Subdivision Authority

File No. LDA10-0385

RE: Tentative plan of subdivision to create 30 single detached residential lots from a portion of SE 19-53-25-4, located west of 199 Street; **BIG LAKE NEIGHBOURHOOD ONE**

SUBDIVISION CONDITIONS OF APPROVAL MAP

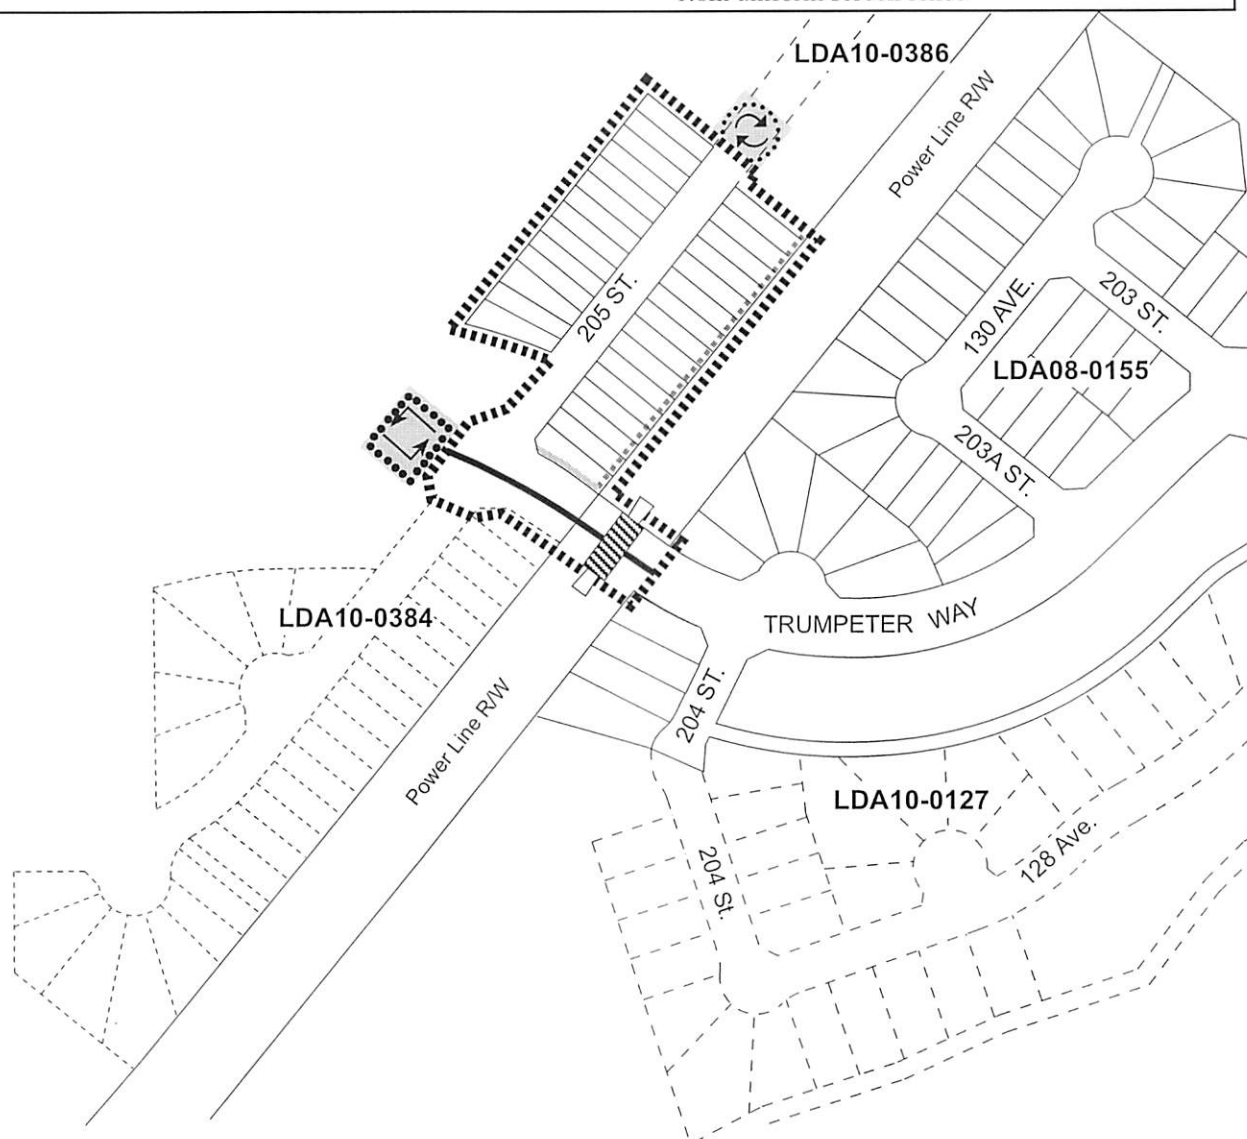
10. that the Engineering Drawings include an offset 17 m radius asphalt surface temporary transit turn around with bollards or mini-barriers, as shown on the "Conditions of Approval" map, Enclosure I. The turnaround will be required to be gravel prior to CCC and asphalt prior to FAC or at the discretion and direction of the Transportation Department as shown on the "Conditions of Approval" map, Enclosure I;

11. that the Engineering Drawings include an easement for a 12 m radius gravel surface temporary turn around with bollards or mini-barriers as shown on the "Conditions of Approval" map, Enclosure I;

12. that the owner provide a zebra marked crosswalk with curb ramps and pedestrian signage at the mid-block crossing as shown on the "Conditions of Approval" map, Enclosure I;

13. that the owner construct all fences positioned wholly on privately owned land as shown on the "Conditions of Approval" map, Enclosure I; and
14. that the owner is responsible for the design, landscaping and construction within the public utility lots, utility right-of-way, road islands, boulevards, medians, walkways and Municipal Reserve parcels, to the satisfaction of the Community Services, Transportation and Asset Management and Public Works Departments.
